1984 Corvette: Service Bulletin: Side Door Lateral Movement

Source: Chevrolet Dealer Service Bulletin

Bulletin No: 84-118, Section: 10 (I)

Date: April, 1984

FIGURE 1

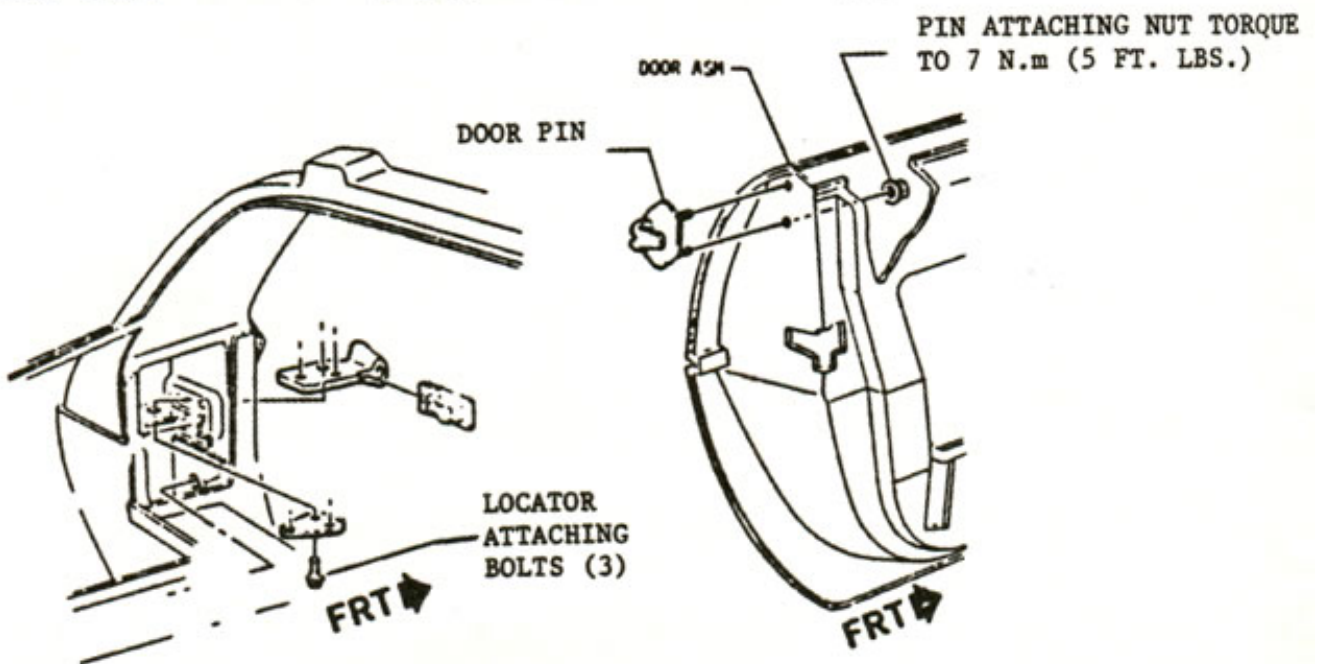
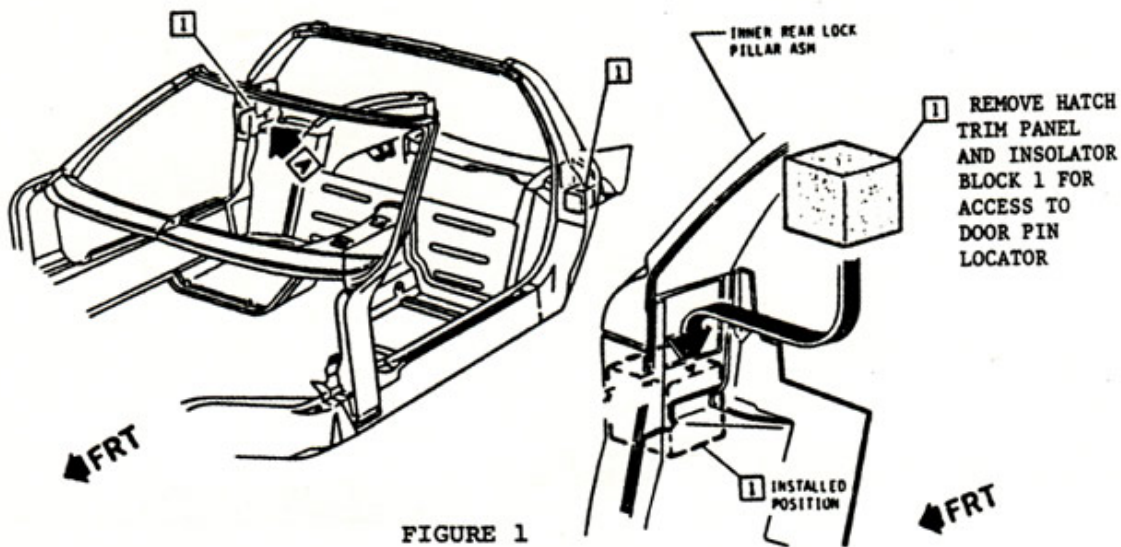
Verify the plastic sleeve is installed in the pin locator assembly. With the vehicle door closed, loosen the locator three (3) attaching bolts (see Figure 1). The locator assembly is to be centered fore-aft and vertically on the door pin. Push the locator outboard to fully engage the door pin and tighten the locator attaching bolts to 11 N.m (8 ft. lbs.)

FIGURE 2

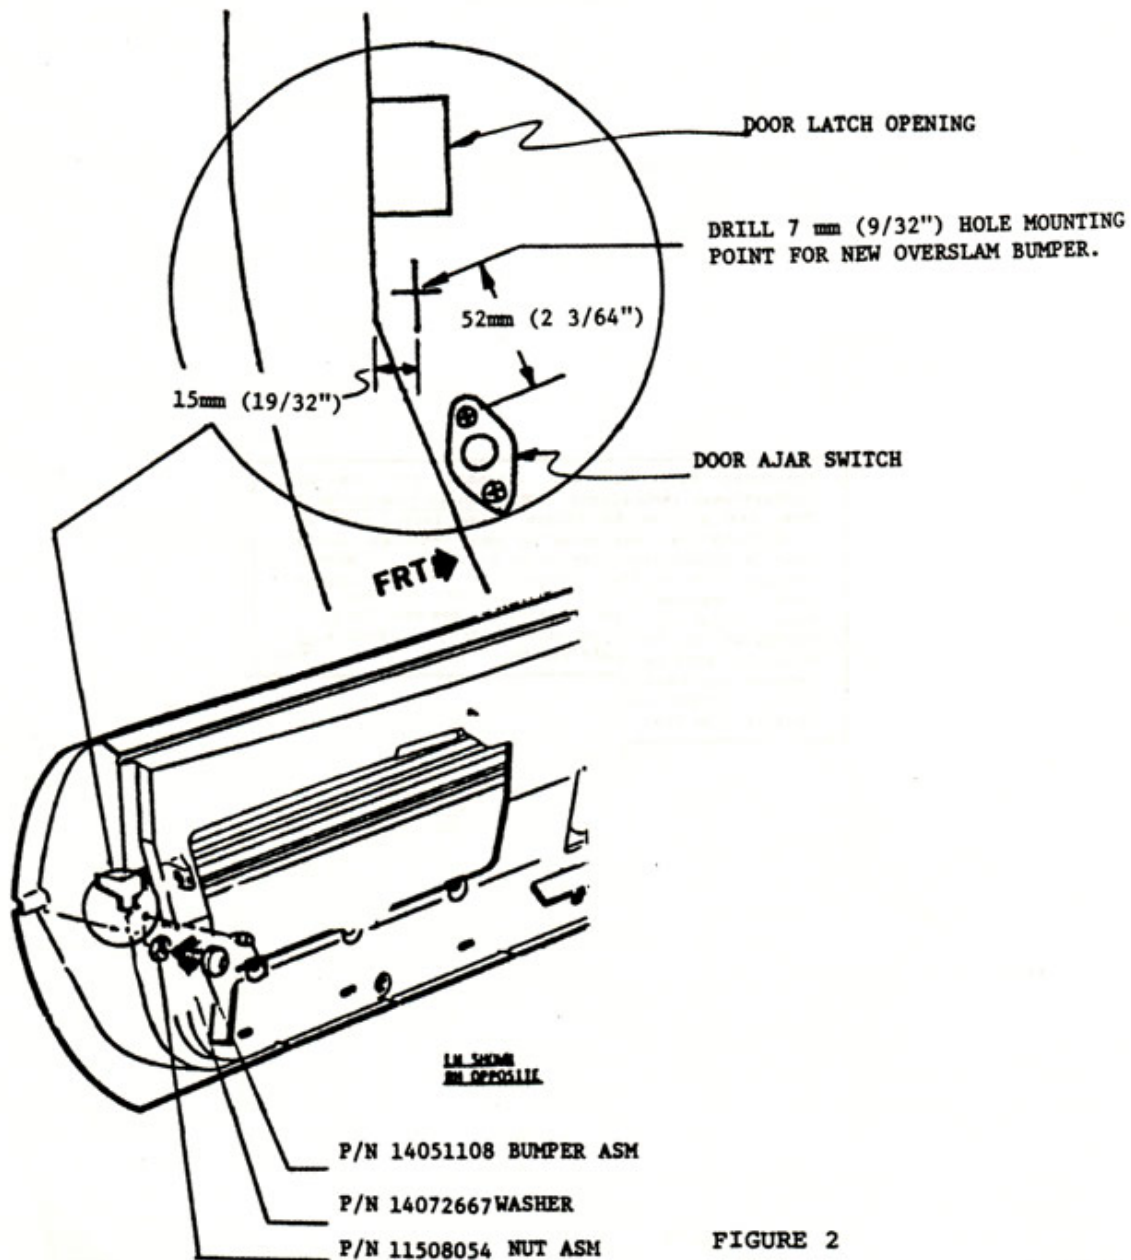
Some early built vehicles did not have overslam bumpers. If this is the case, it will be necessary to drill a 7mm (9/32") hole in the door (see Figure 2).

Add shims (washers) between bumper and door, as required, to eliminate lateral door movement (see Figure 2). DO NOT "OVERSHIM" BUMPER.

Replace the discarded production bumper(s) with bumper, P/N 14051108, attaching nut, P/N 11508276, and P/N 14072667, flat washers, which are to be used as bumper shims. The number of shims required will vary from vehicle to vehicle depending on "Build stacks".

Once shim pack has been established, tighten bumper retaining nut to 12 N.m (9 ft. lbs.) and check the door ajar lamp for proper operation. The door ajar switch is self-adjusting and cannot be reset.
